Great Lakes UK Limited
Great Wolf Lodge, Chesterton, Bicester

Non Material Amendment (S.96a) Application
Design Changes

March 2023

Proposed Amended Scheme - Second Floor

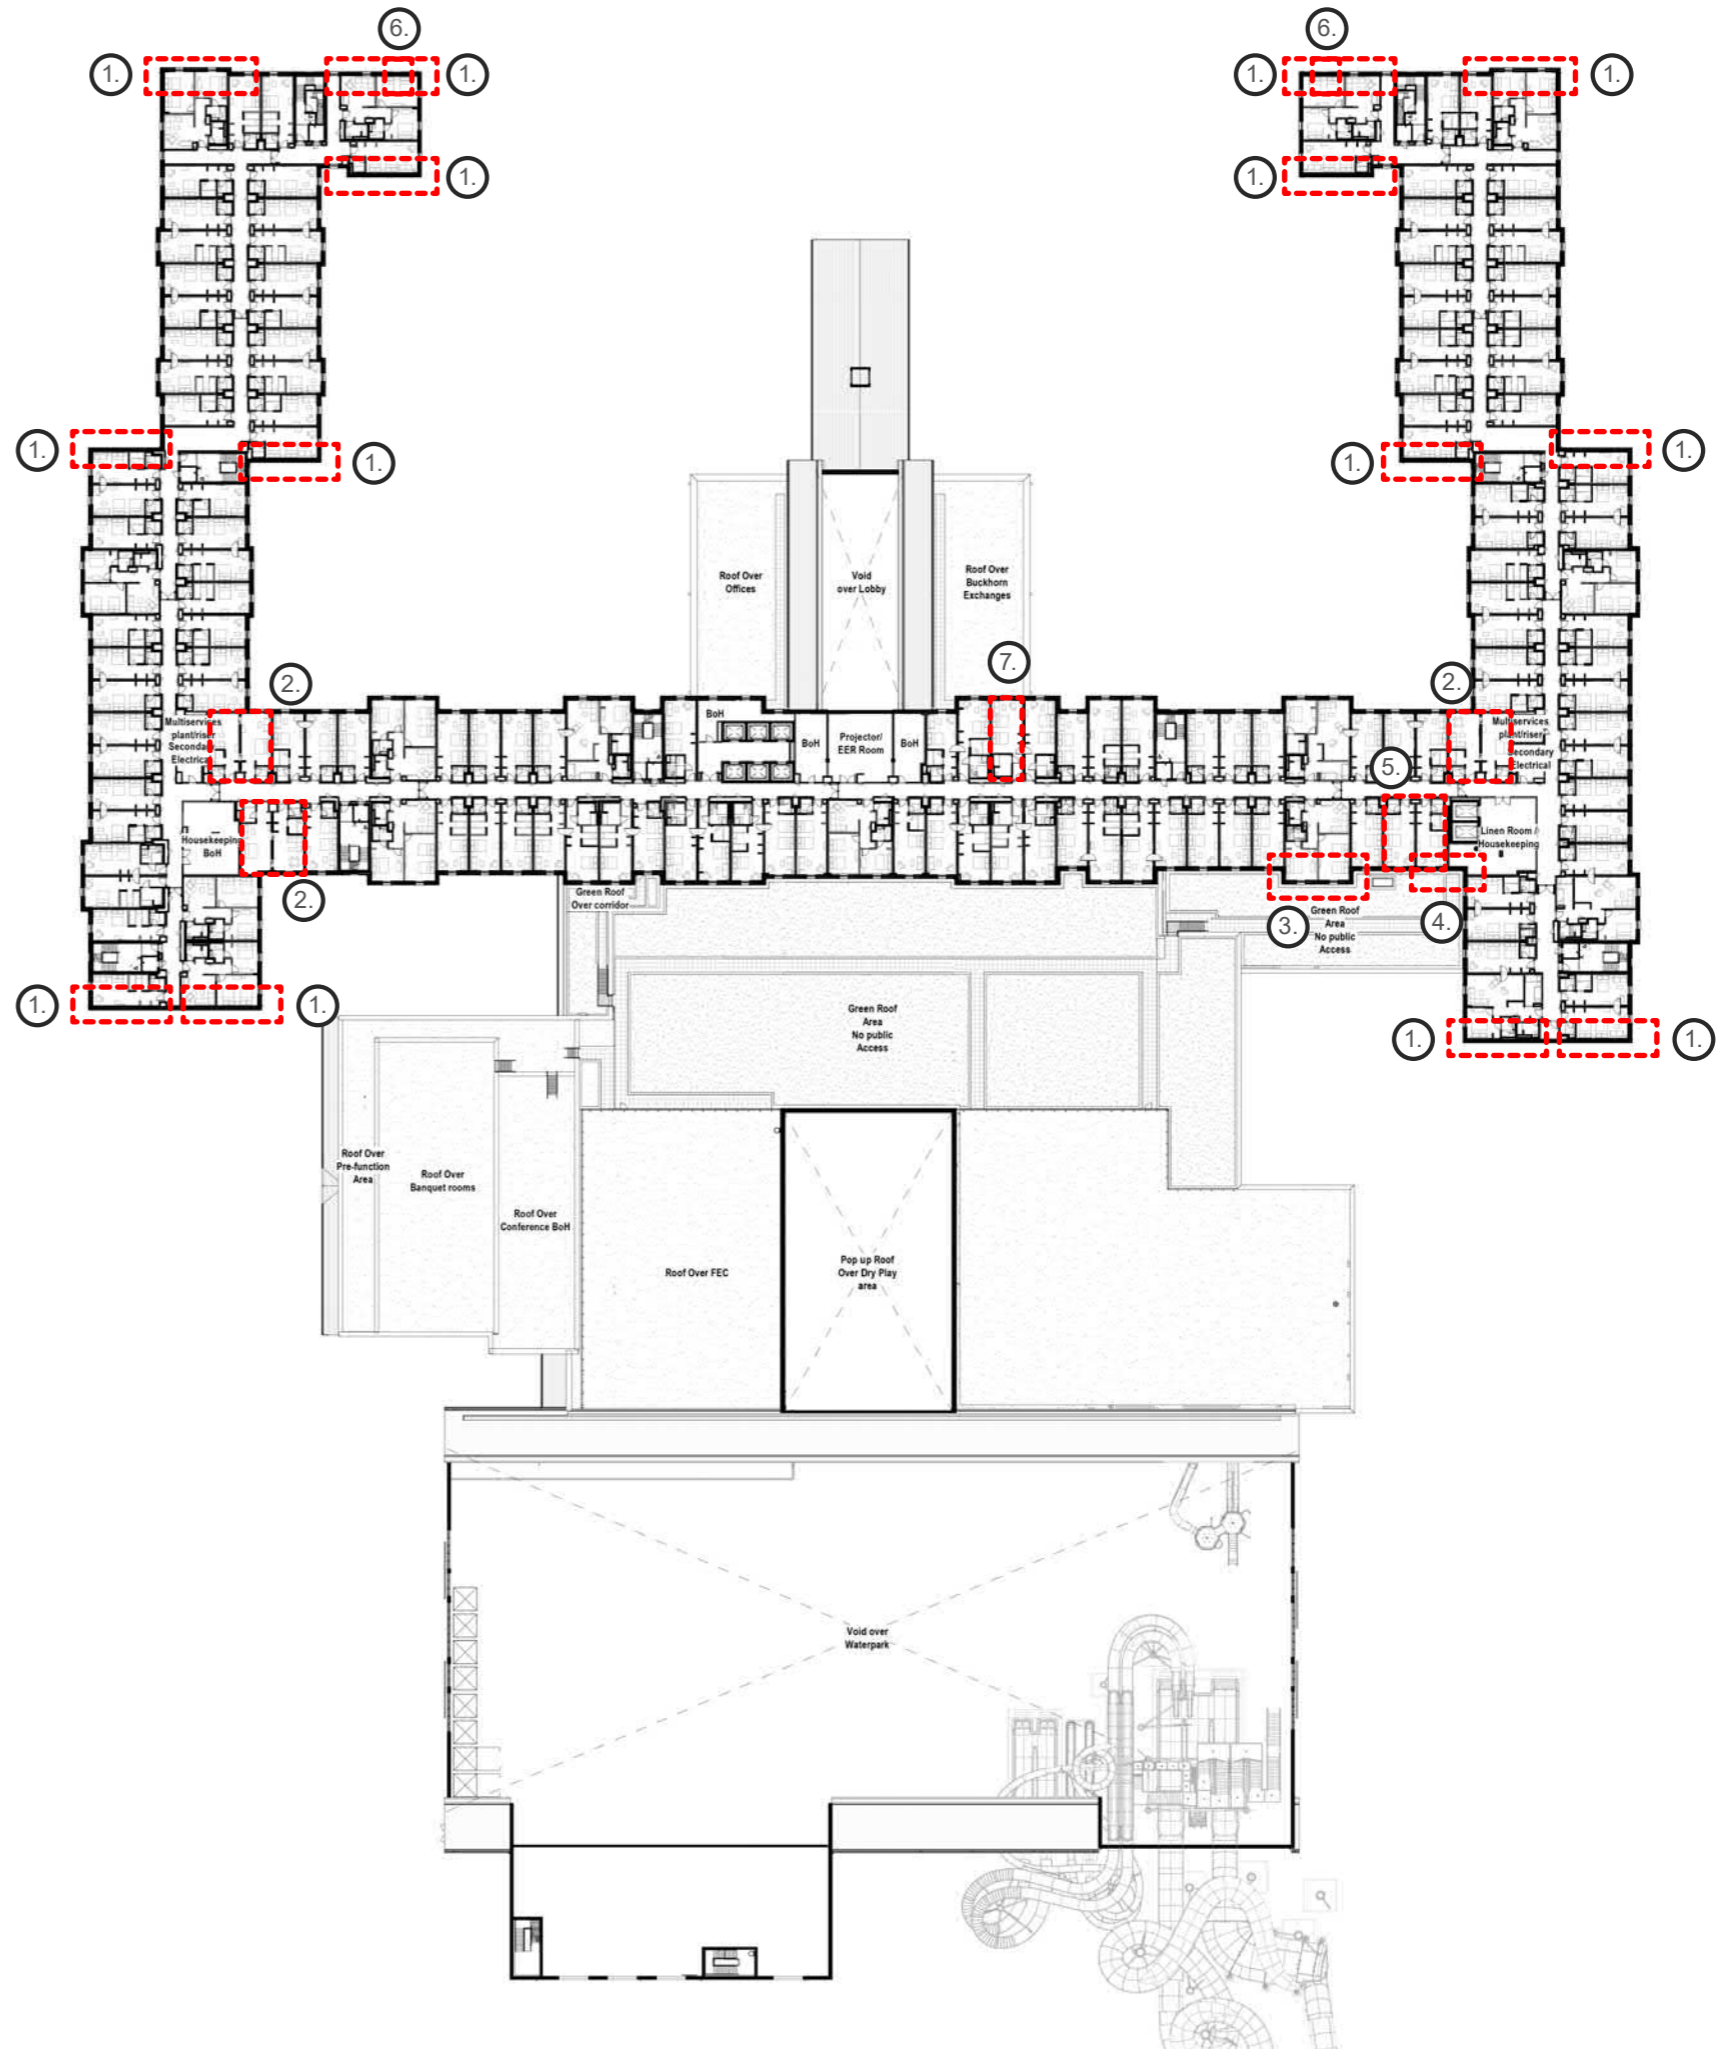
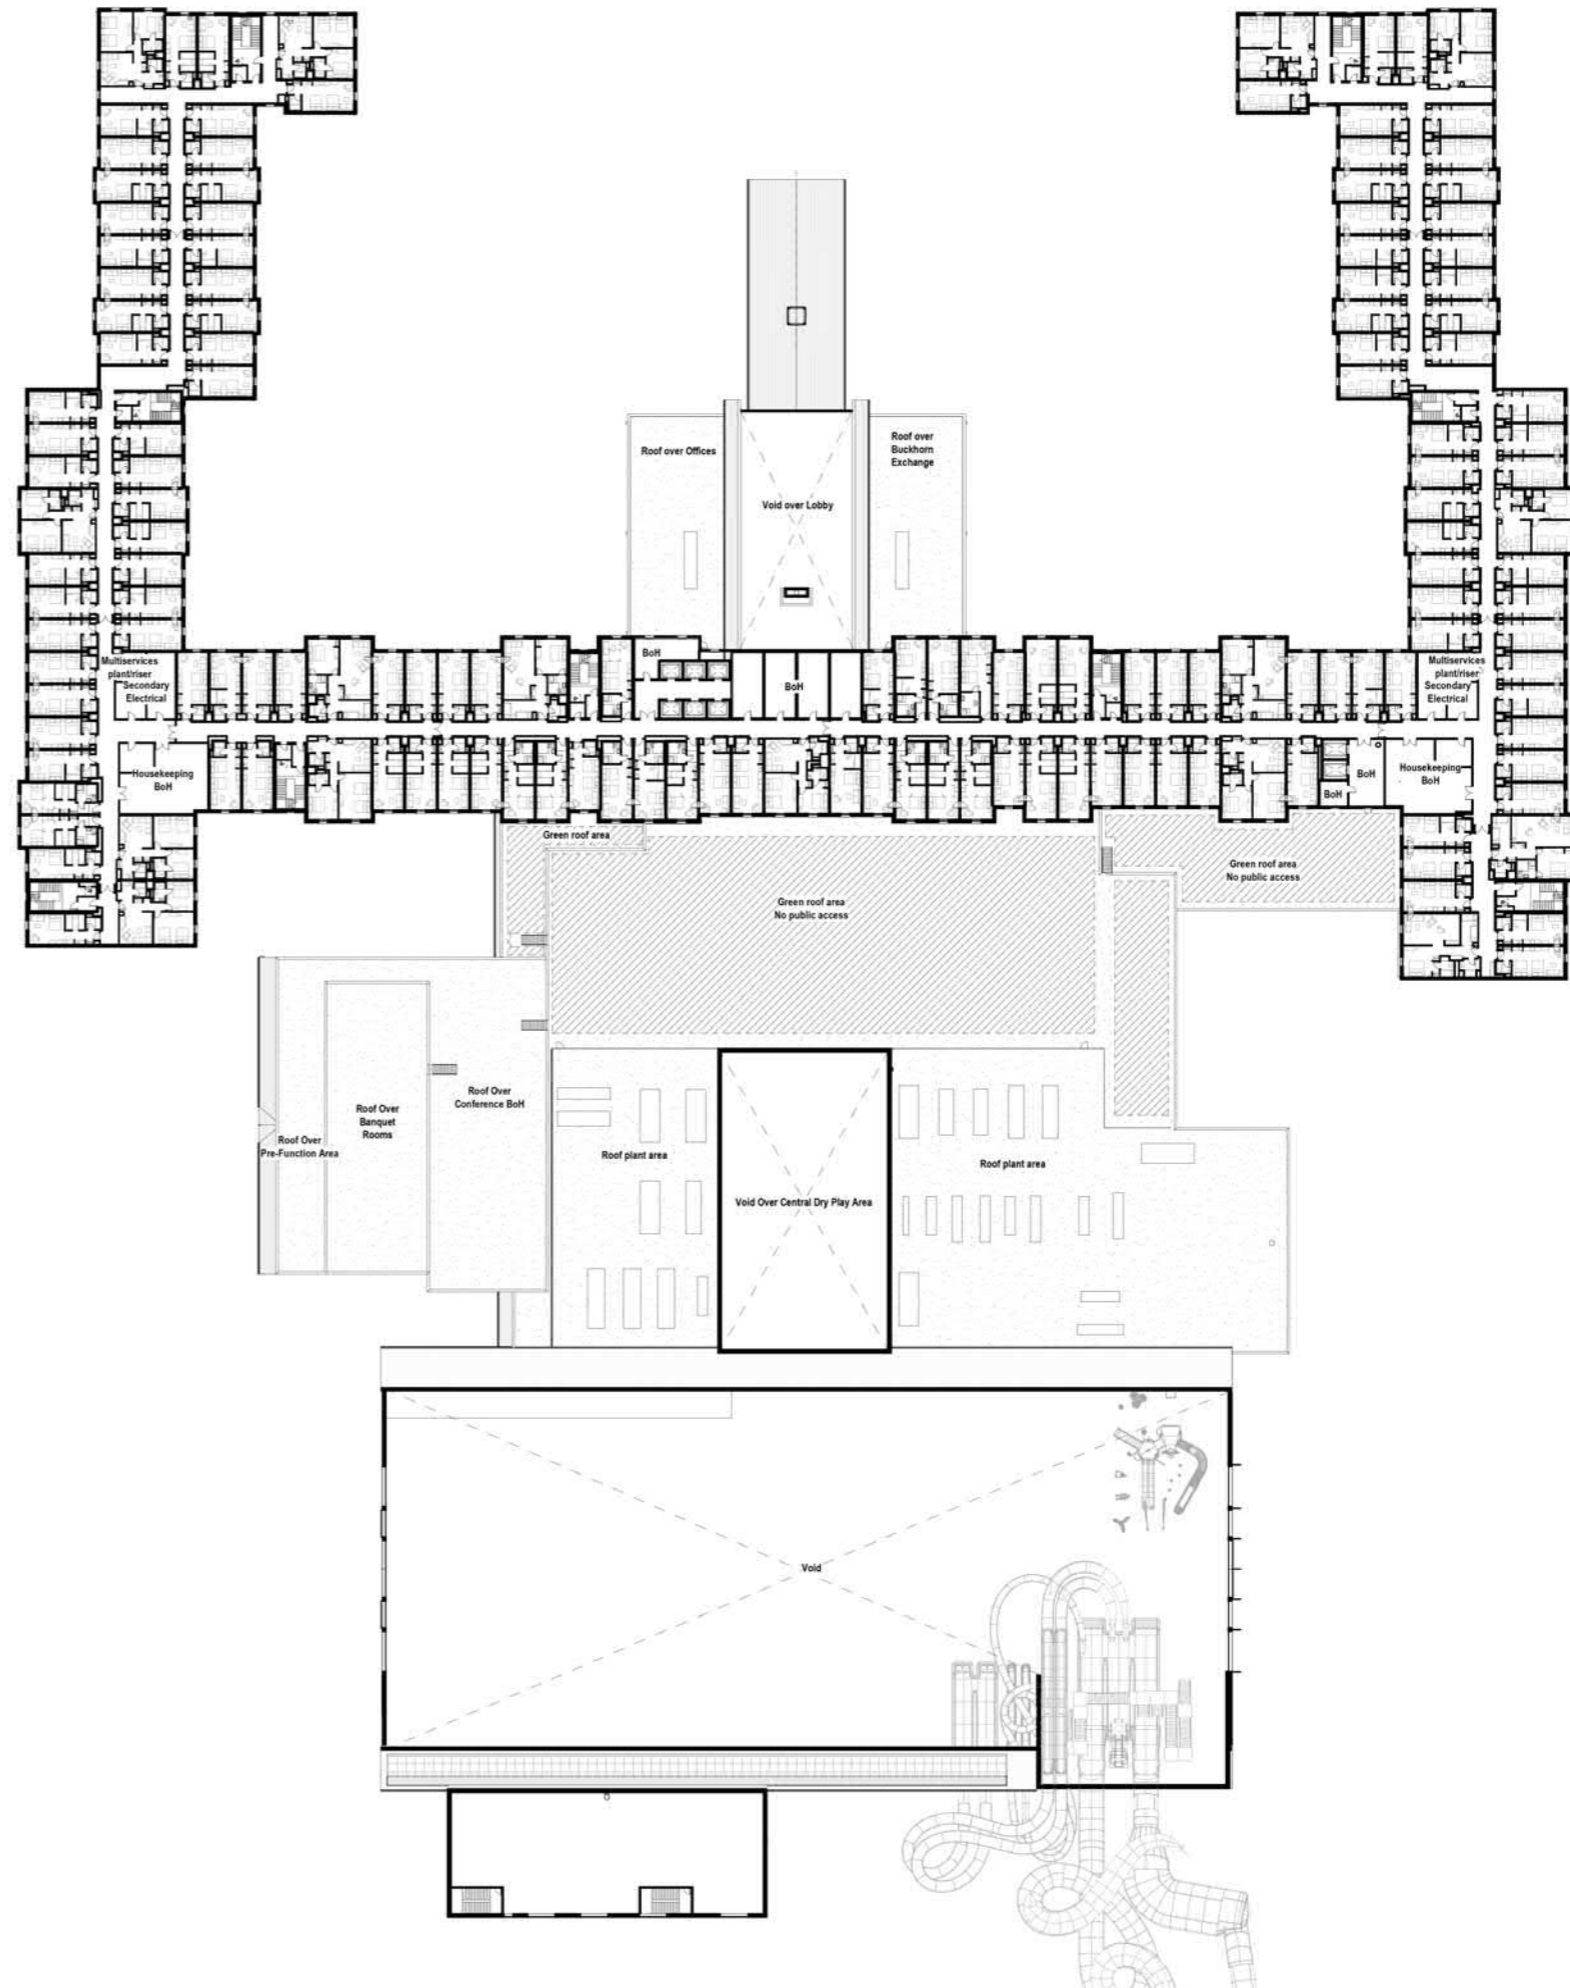
- ① Facades pushed out to allow columns not to protrude into guestrooms.
- ② Corner guestrooms changed to new enlarged types on every floor. 12 no. total rooms affected but no increase in room numbers with this change and no facade changes.
- ③ Façade wall moved down 100mm to align with equivalent wall on left hand side.
- ④ 2x Windows added on levels 1-3 and door added on right on level 1 to provide safer roof access.
- ⑤ 6 No. total additional keys added where shown on levels 1-3. Total guestroom count to be 504.
- ⑥ Replace windows in corner rooms (where there were two windows in room) to recessed reveal detail.
- ⑦ Adaptable and hoist provisions to be installed post completion when required.
